**RE: Bipole III Transmission Project – Public EIS review and TAC comments**

Bipole III Transmission Project

Public Review and TAC Comments

MCWS/MH-TAC

26 **Figure 1. Comparisons of annual range sizes among boreal woodland caribou**  
 27 **populations and summer resident Pen Island caribou**

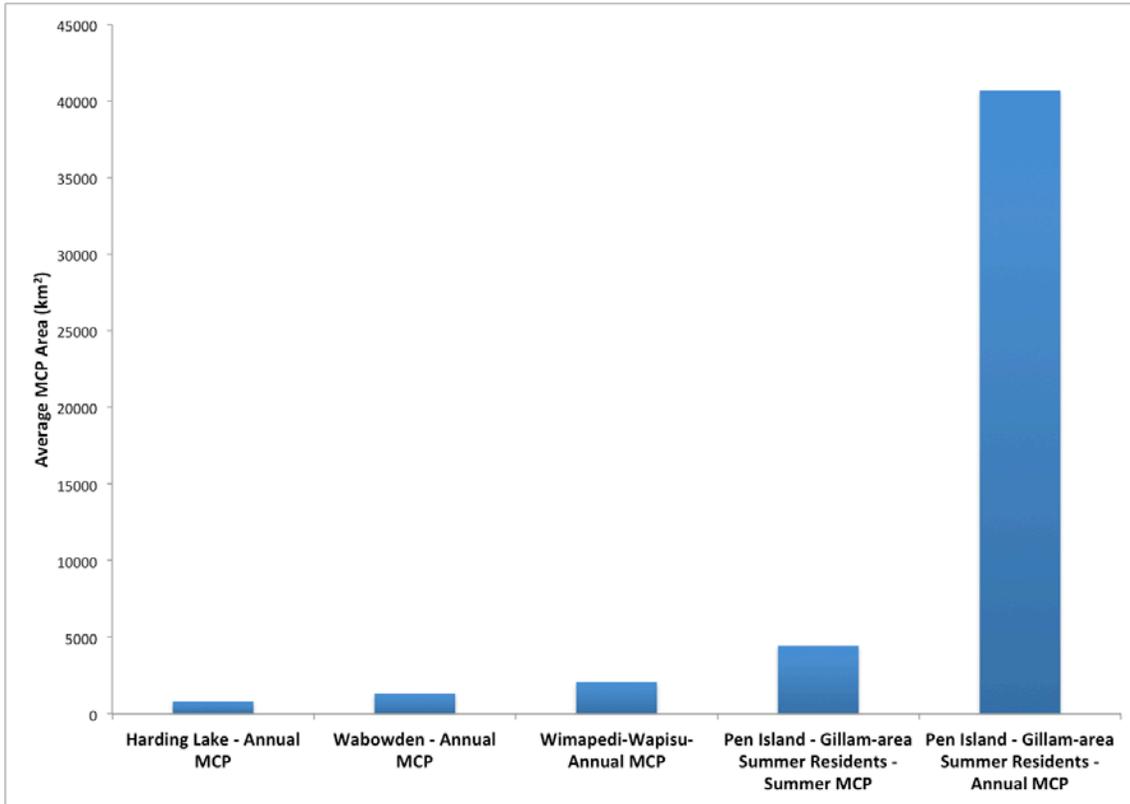
3 P. 8-87 – Provide more information on Coastal Caribou species as compared to  
4 woodland caribou.

7 Comparisons of boreal woodland caribou range were conducted with coastal  
8 populations to better compare these two ecotypes of *Rangifer tarandus caribou*. Total  
9 annual Minimum Convex Polygons (MCP) for the Wabowden, Wimapedi-Wapisu, and  
10 Harding Lake boreal woodland caribou ranges, and total summer MCPs for the Gillam-  
11 area “summer resident” Pen Island range were calculated and average area for each  
12 range was computed. For all ranges, only those animals for which a minimum of one  
13 year of telemetry data had been collected were included. Consequently, range average  
14 MCPs were based on 21 animals in Wadowden, 32 animals in Wimapedi-Wapisu, 18  
15 animals in Harding Lake, and six Pen Island animals identified as Gillam-area summer  
16 residents.

17 The average MCP areas are illustrated in Figure 1. All boreal caribou ranges were  
18 observed to have significantly smaller annual range MCP areas than the summer MCP  
19 area exhibited by the Pen Island summer residents. The Pen Island average summer  
20 MCP occupied an area of approximately 4,426 km<sup>2</sup>. Wimapedi-Wapisu, the largest  
21 boreal range, encompassed approximately 2,279 km<sup>2</sup>, or 47% of the Pen Island
